[Docket No. 99-CE-85-AD]

Airworthiness Directives; EXTRA Flugzeugbau GmbH Models EA-300, EA-300L, and EA-300S Airplanes

ACTION: Notice of proposed rulemaking (NPRM).

Figure 1

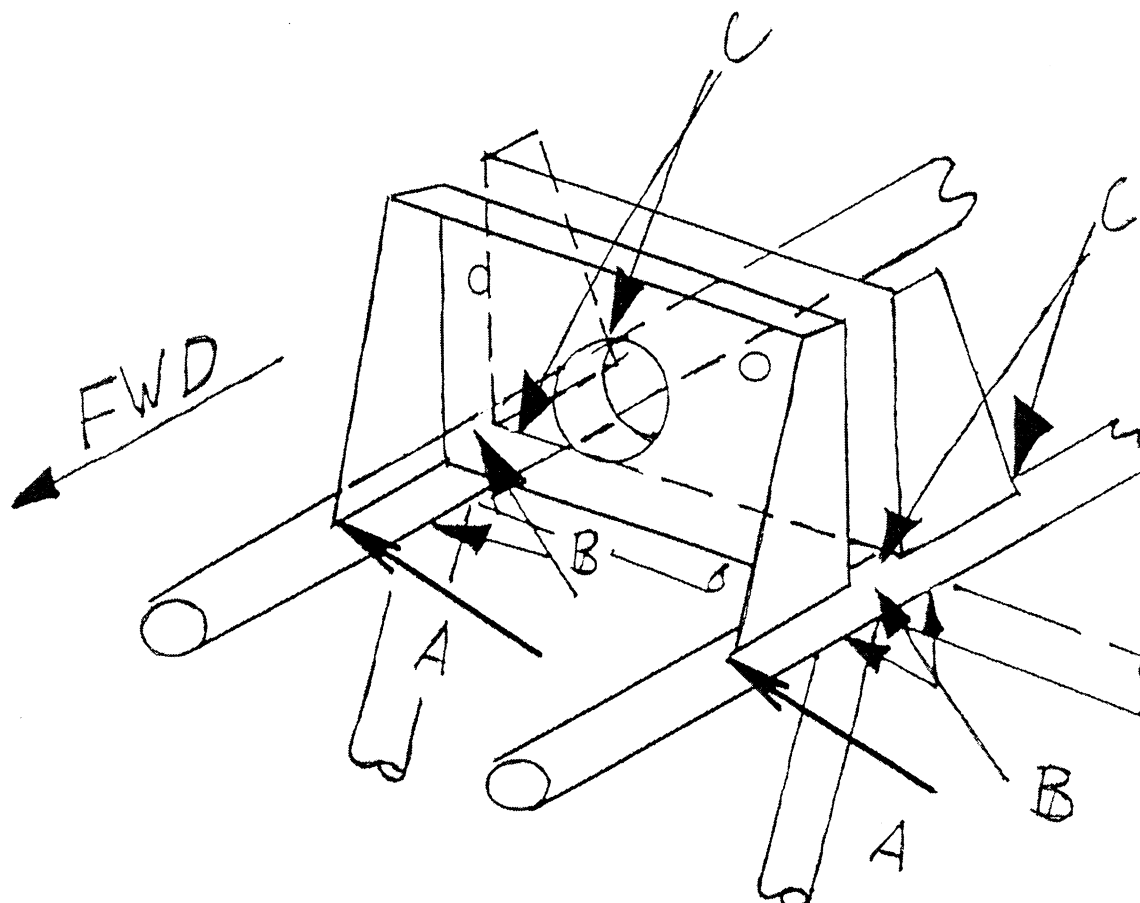
Actions	Compliance	Procedures
(1) For all affected airplanes, inspect, using a fluorescent dye penetrant method, the upper longeron at the horizontal stabilizer attachment for cracks in the areas depicted in Figure 1 of this AD.	Upon accumulating 250 hours time-in-service (TIS) or within the next 50 hours TIS after the effective date of this AD, whichever occurs later.	In accordance with Part I of Extra Service Bulletin No. 300-2-95 (pages 2-6 at Issue: C, dated July 15, 1998; and pages 1 and 7 through 11 at Issue: D, dated January 30, 2001). No further action is required by this paragraph if the modification is already accomplished in accordance with Part II of Extra Service Bulletin No. 300-2-95 (all pages at Issue: C, dated July 15, 1998).

(3) For all affected airplanes, if any crack is found during the inspection required by this AD and the crack(s) is(are) in Area A or Area B as depicted in Figure 1 of this AD, accomplish the following: (i) Repair and modify the upper longeron at the horizontal stabilizer attachment; and (ii) Weld the cracks tight during repair.	Prior to further flight after the inspection where any crack is found in Area A or Area B as depicted in Figure 1 of this Ad.	In accordance with Part II of Extra Service Bulletin No. 300-2-95, Issue: D, dated January 30, 2001. No further action is required by this paragraph if already accomplished in accordance with Part II of Extra Service Bulletin No. 300-2-95 (all pages at Issue: C, dated July 15, 1998).

(4) For all affected airplanes, if any crack is found during the inspection and the crack(s) is(are) in Area C as depicted in Figure 1 of this AD, accomplish the following: (i) Obtain a repair scheme from the manufacturer; (ii) Incorporate this repair scheme; and (iii) Accomplish any follow-up actions as directed by the FAA.	Prior to further flight after the inspection where any crack is found.	In accordance with a repair scheme obtained from EXTRA Flugzeugbau GmbH, Flugplatz Dinslaken, D-46569 Hünxe, Federal Republic of Germany; telephone: (0 28 58) 91 37-00; facsimile: (0 28 58) 91 37-30. Obtain this repair scheme through FAA at the address specified in paragraph (f) of this and AD.
